Re: October 18th, 2007 Comments on 2BB-MRY0710/Wastewater Management Plan/Mary River Project/Baffinland Iron Mine Corporation

We thank you for your comments in your response dated October 18th with regards to Baffinland Iron Mine Corporations (BIMC) Wastewater Management Plan. Responses to comments are found below in numerical order corresponding with the INAC letter.

**BAFFINLAND MINE
MARY RIVER SITE**

HEAT TRACE PLAN AND DETAILS

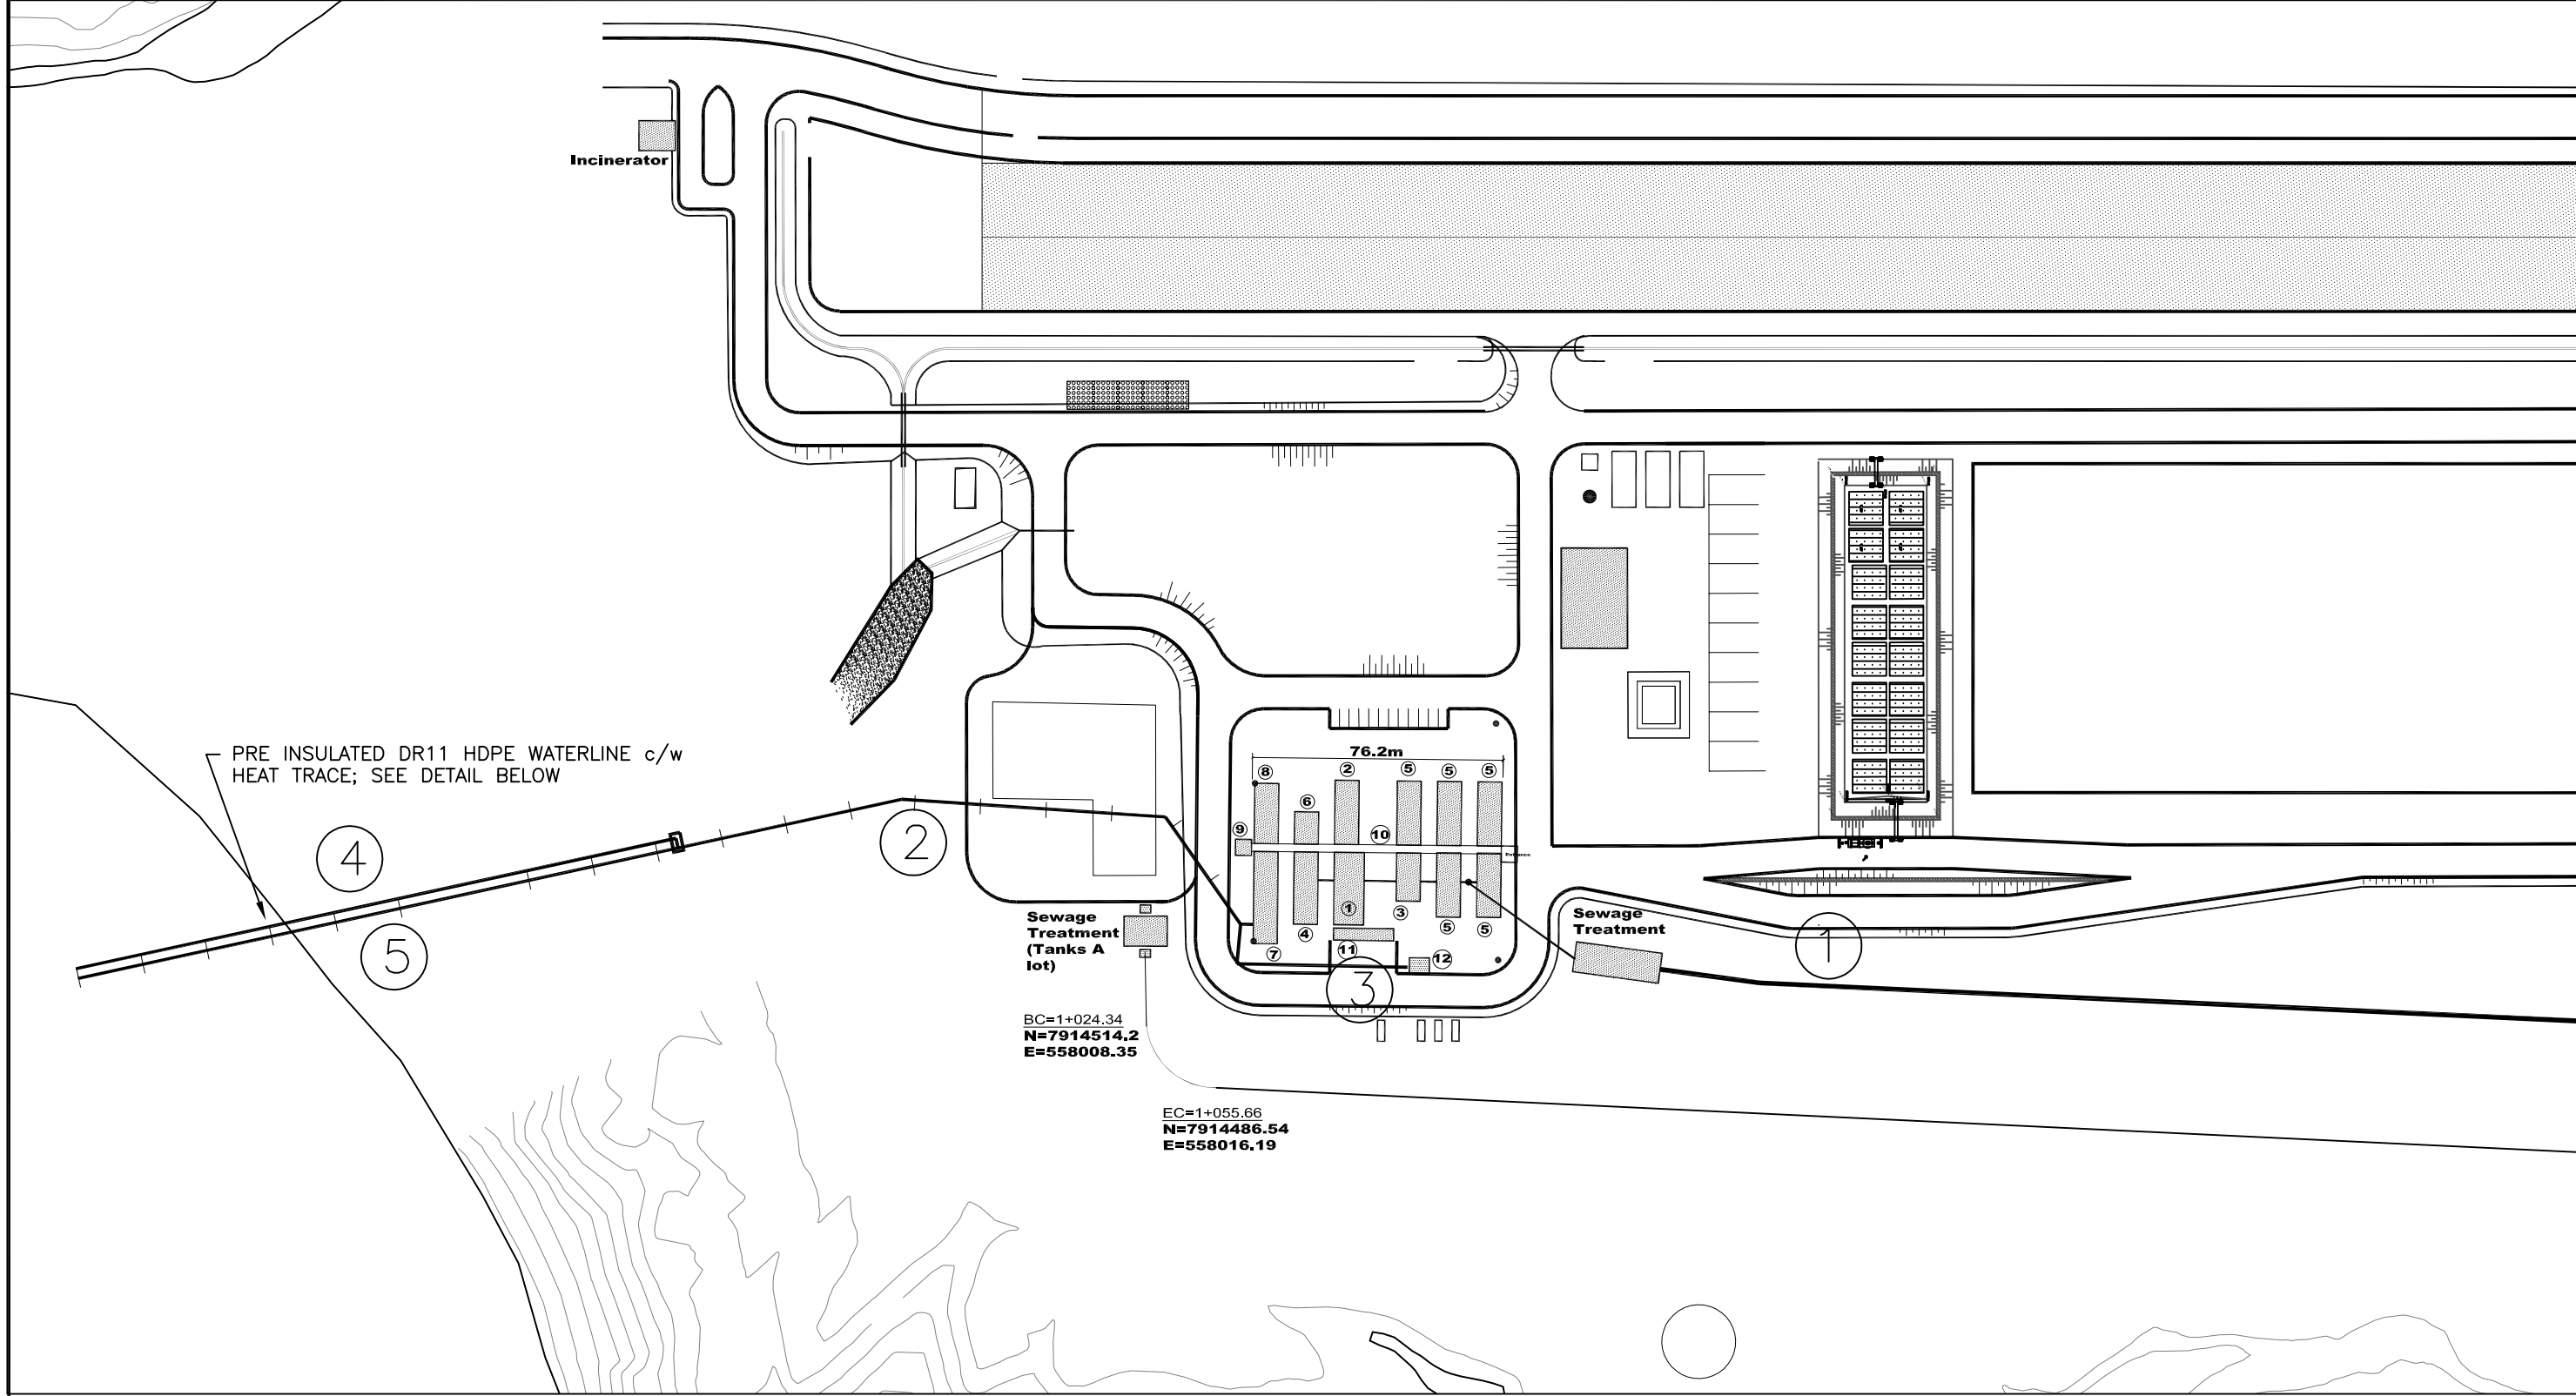
5. **The Wastewater Management should include a detailed description of the drainage ditch situated at the Milne Inlet site. Section 9.3 refers to this ditch as being large, wide and several hundred meters in length. Approximate dimensions of the ditch, observed vegetation, and recorded water levels would allow a better understanding of the receiving environment.**

A detailed description of the ditch is included as a Figure 2 attached to this letter. The dimensions of the ditch are as follows: average width of the drainage ditch is 15 meters, average depth (not water levels but depth of land) is 1.9 meters and approximate length is 275 meters.

HEAT TRACE DETAIL AT SEWAGE DISCHARGE

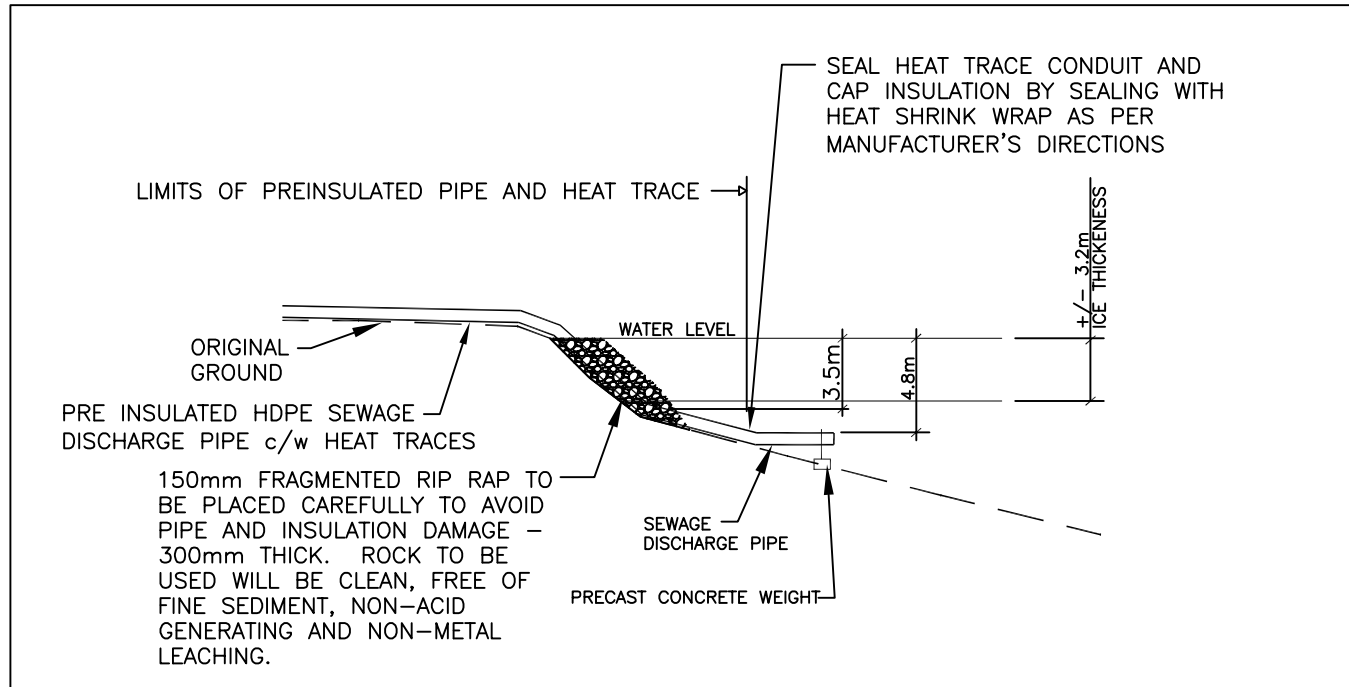
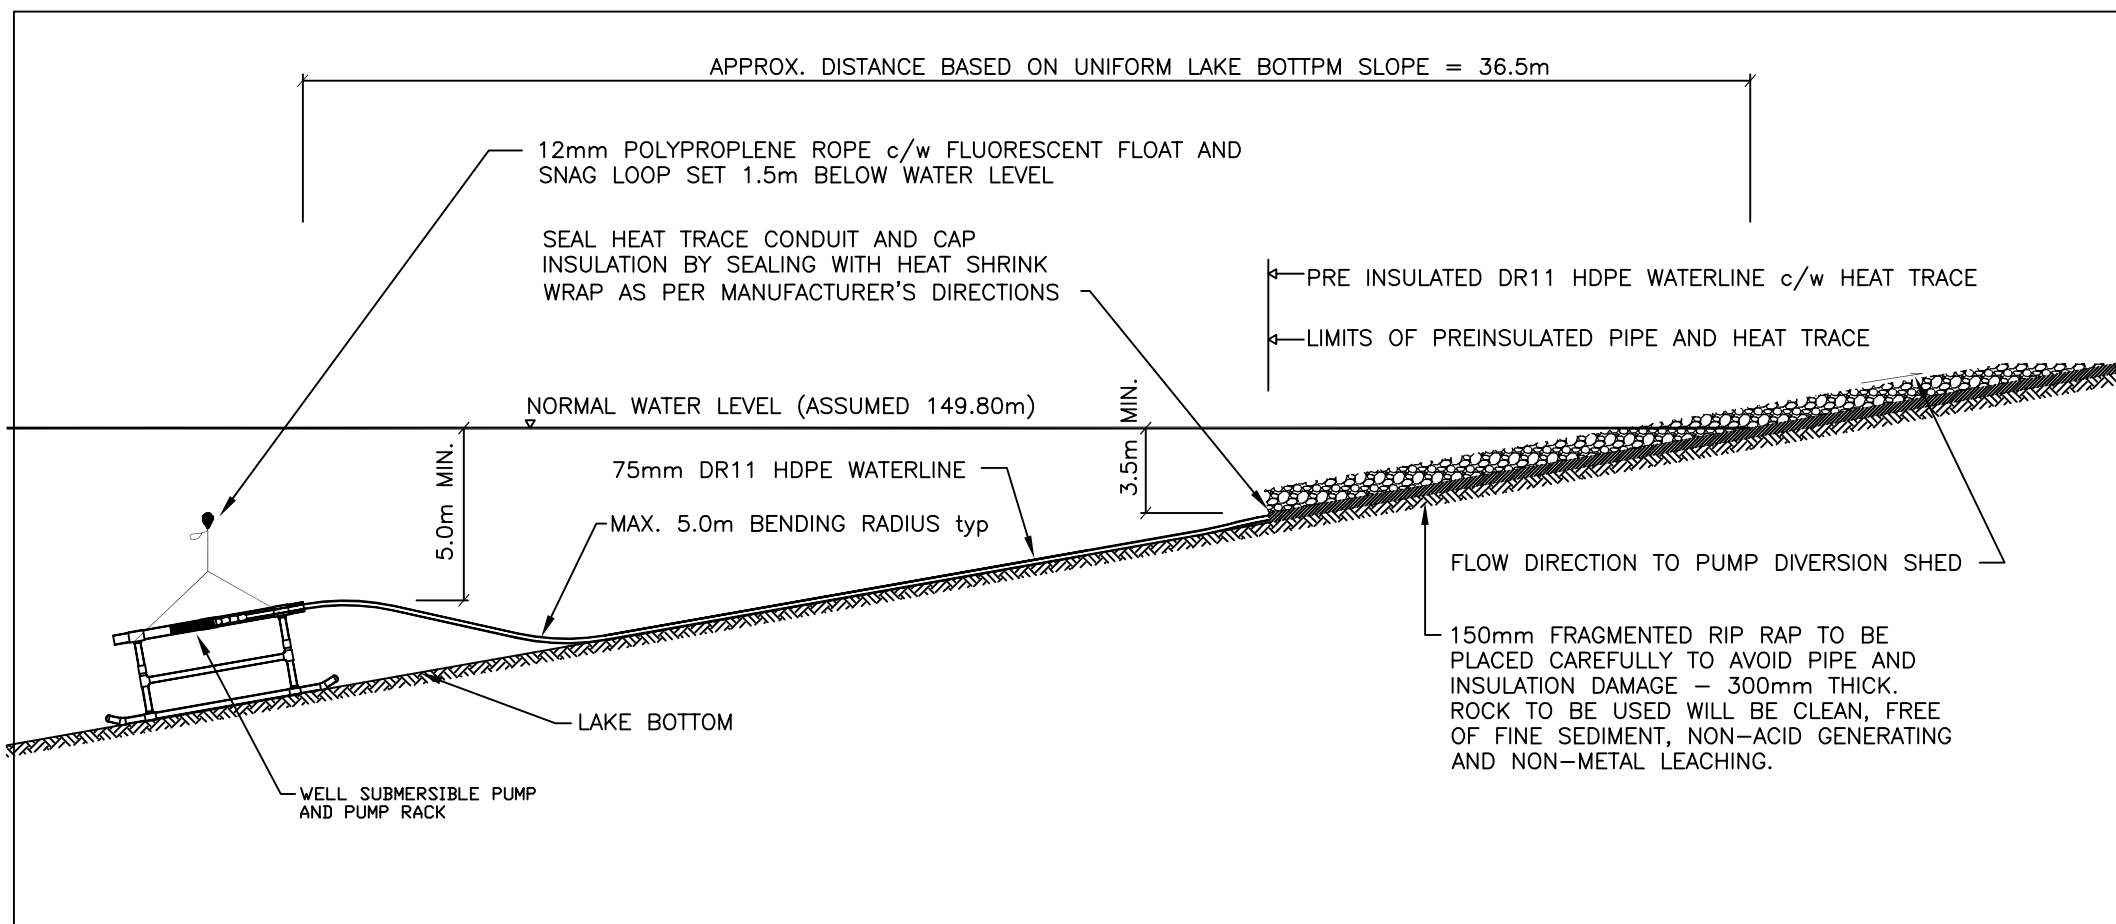
- 2. The proponent to explain how the design of the Mary River Camp's effluent discharge pipeline will prevent the freezing of treated wastewater en route to Sheardown Lake. Section 3.2 of the submitted Plan states the freeze protection measures include having a pipeline constructed of high density polyethylene, polyurethane insulation, and a heat traced electric thermocable. The proponent should explain why it intends to have the portion of pipe within the lake's ice depth to be insulated but not heat traced and why the portion of the pipe below 4 meters depth of the typical water/ice surface will be un-insulated. Having insulation and heat tracing throughout the entire discharge pipeline may be a prudent freeze protection strategy.**

An upgraded design of the sewage outflow pipe into Sheardown Lake includes the heat tracing and insulation to 300mm below the nominal ice level. This will prevent the freezing of the treated wastewater discharged into Sheardown Lake. The attached Drawing Number E104-R3 illustrates the new design of the sewage outflow line at Mary River and will ensure that a freeze protection strategy is in place.
